# CREEKSIDE AT LORSON RANCH FILING 2

## PLANNED UNIT DEVELOPMENT AND PRELIMINARY PLAN

EL PASO COUNTY, CO  
SECOND SUBMITTAL: JULY 18, 2022

# PUD Development Plan -review 2.pdf Markup Summary 8-23-2022

SHEET TITLE:  
**PUD TRACT MAP  
AND DETAILS**

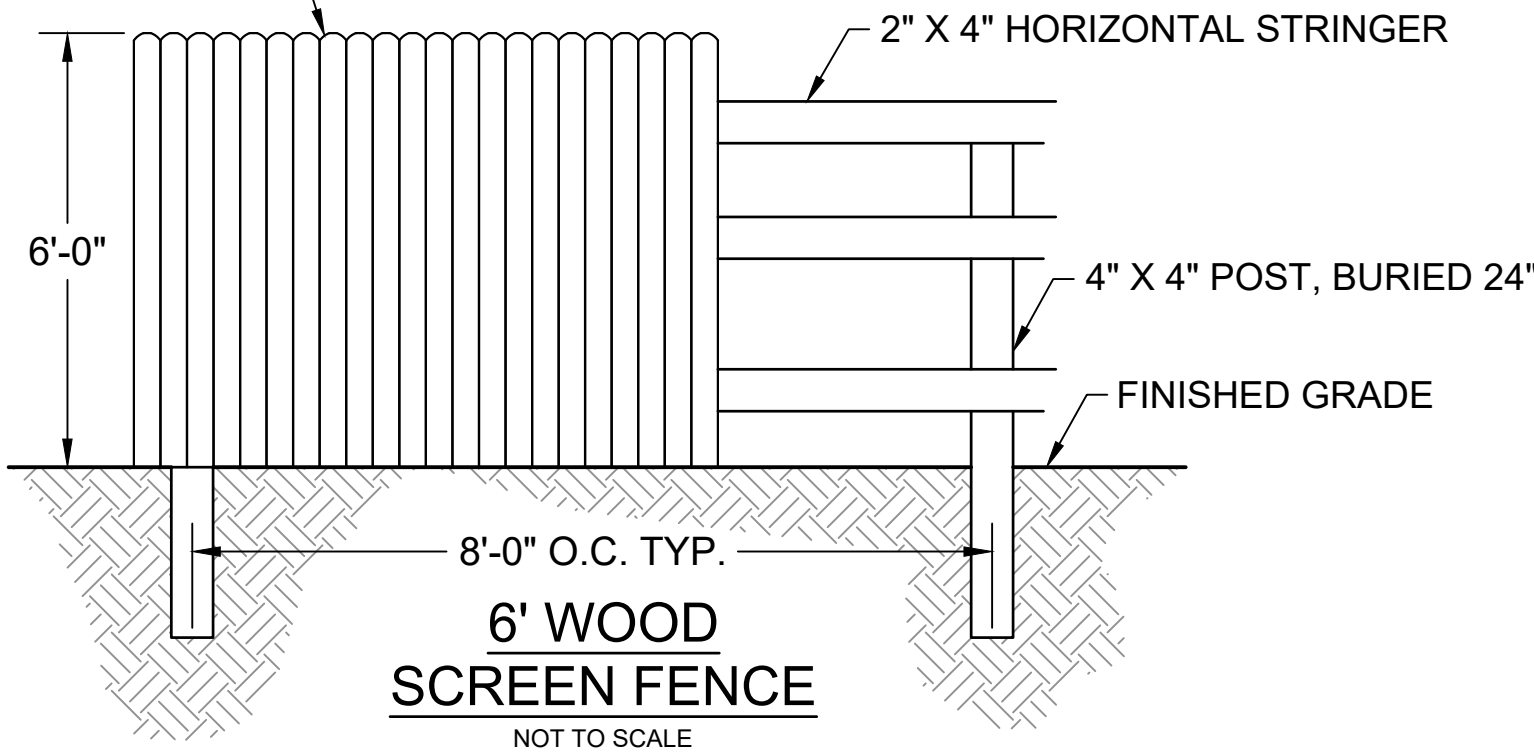
What about making tract a natural pocket park? throw some benches in there for people to sit on watch the creek?

I thought tract A was not a detention pond and is usable openspace?

where did the openspace calcs go?

SHEET 03 OF 08

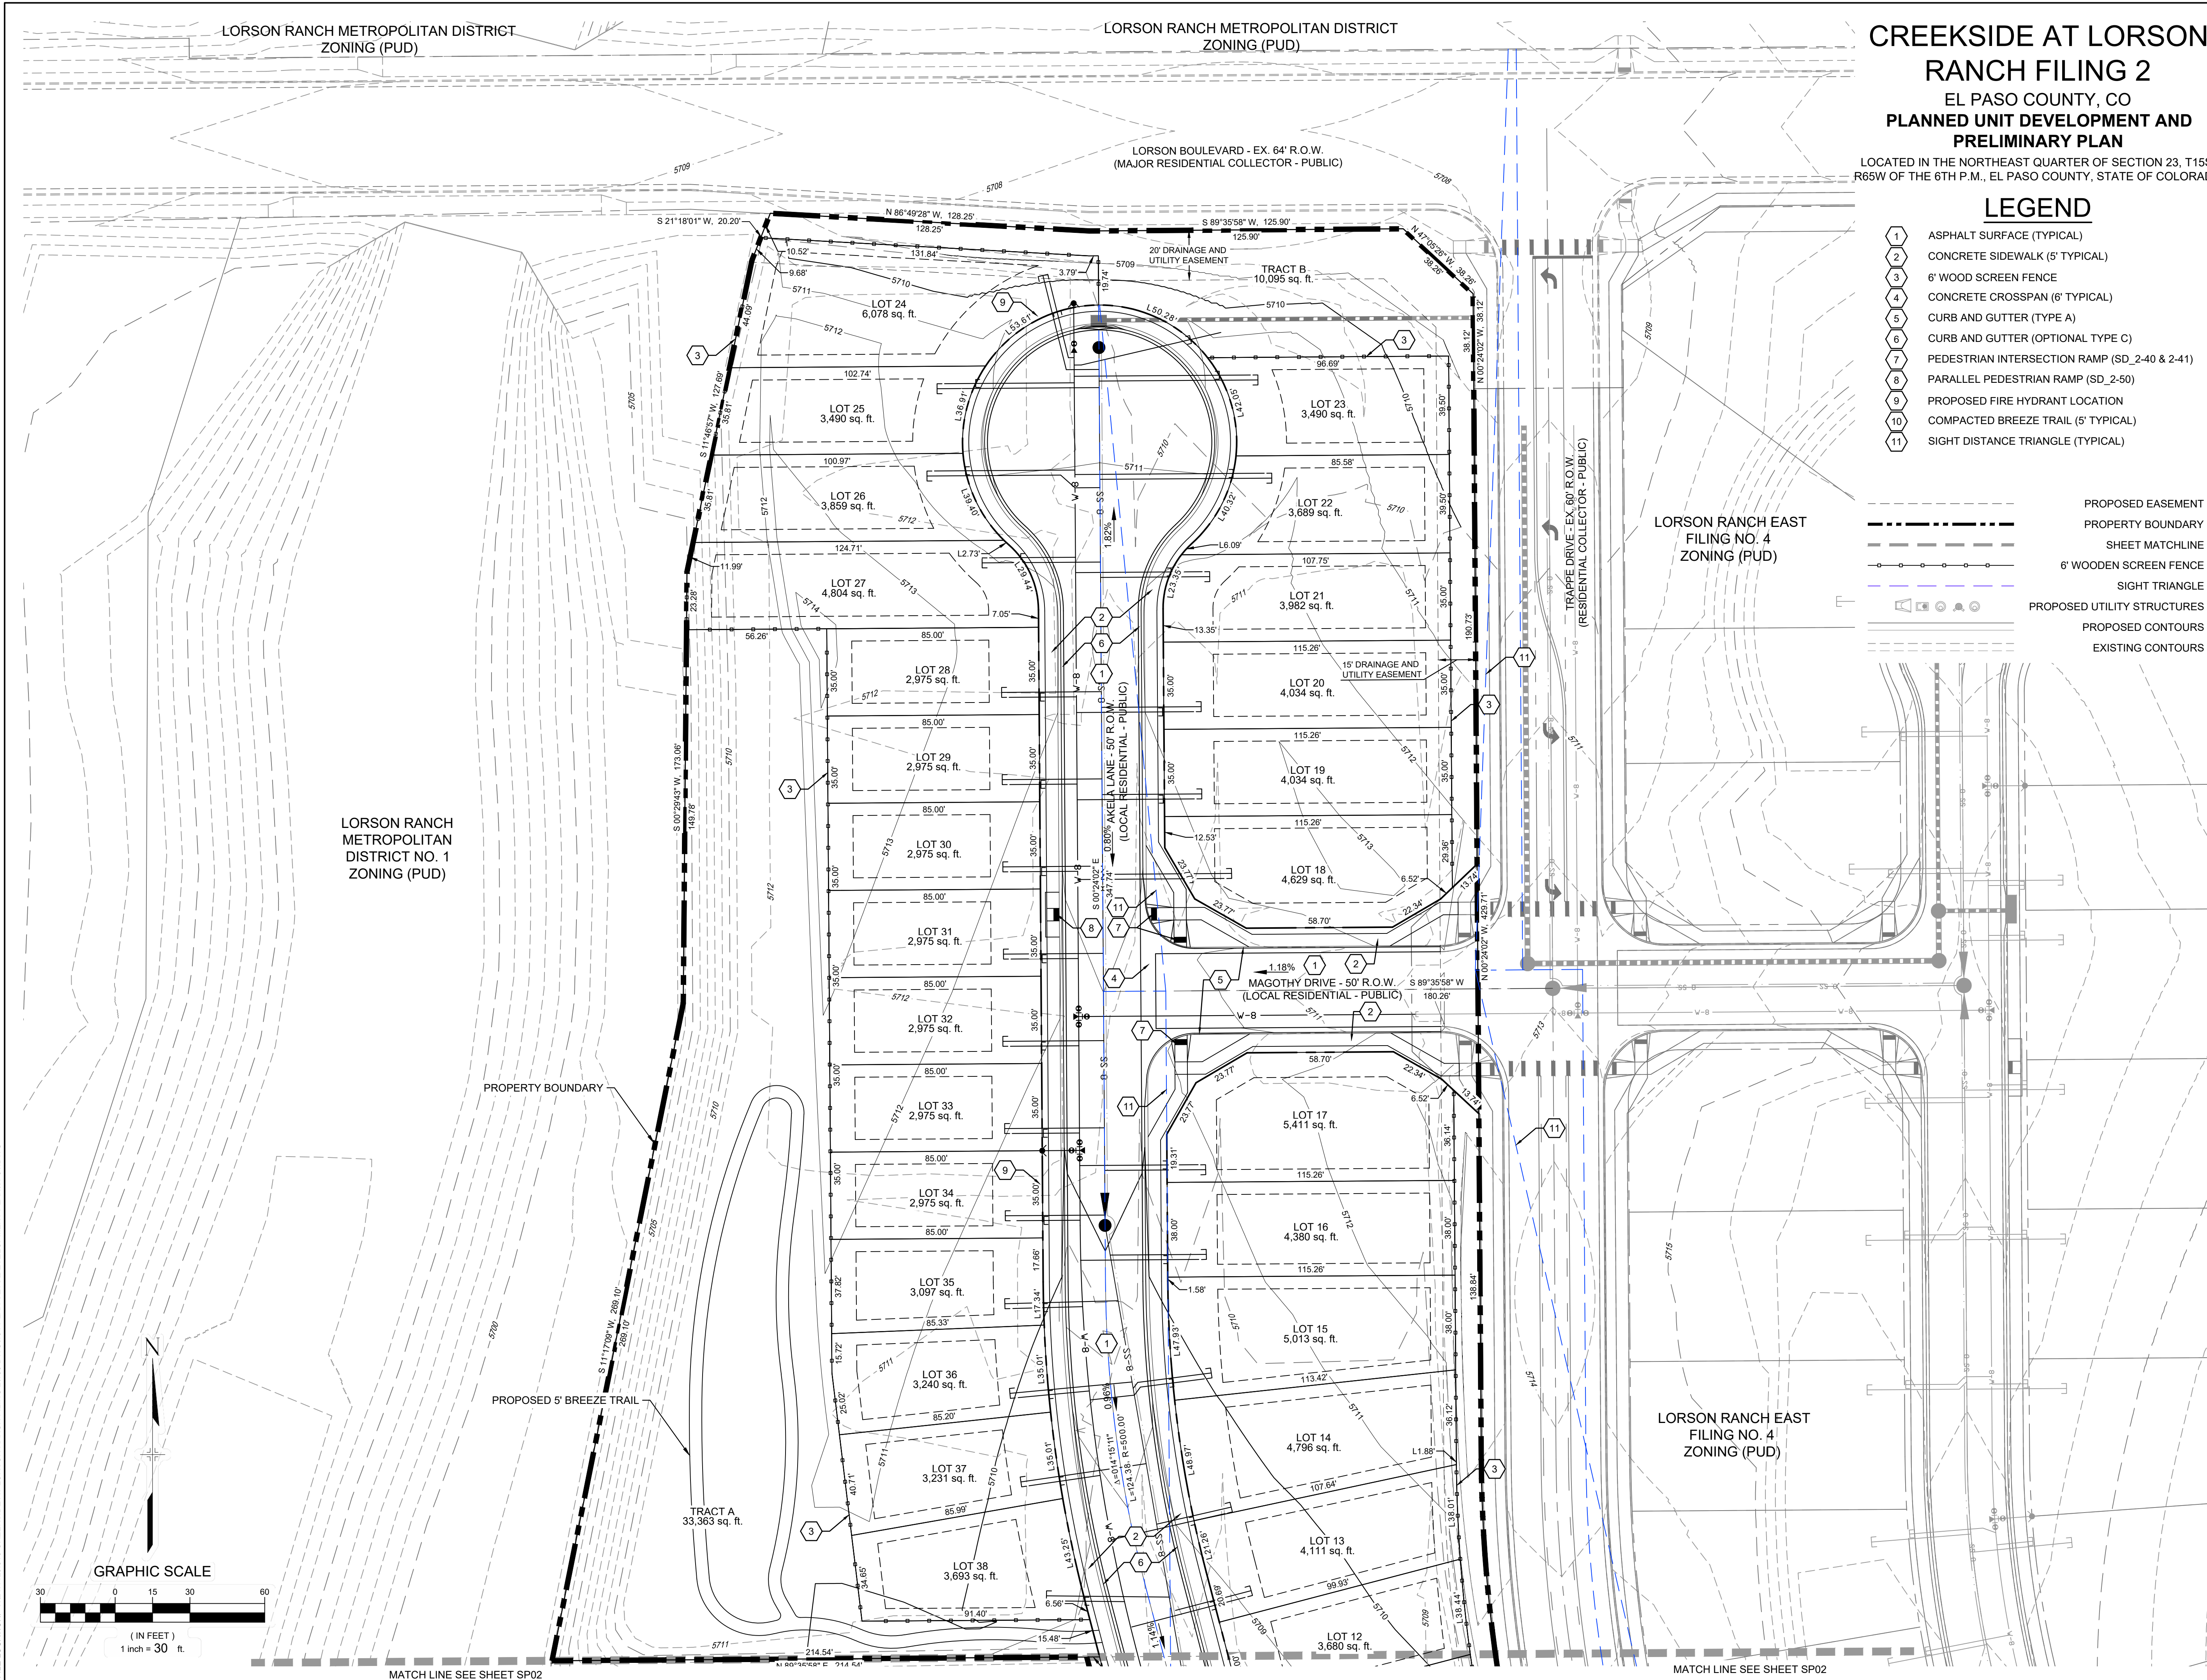
what? a pergola and a covered patio will be higher than 18"

with 5 foot setbacks and easements except for window wells i dont think you can have projections maybe a bay window or fireplace...maybe delete B and C
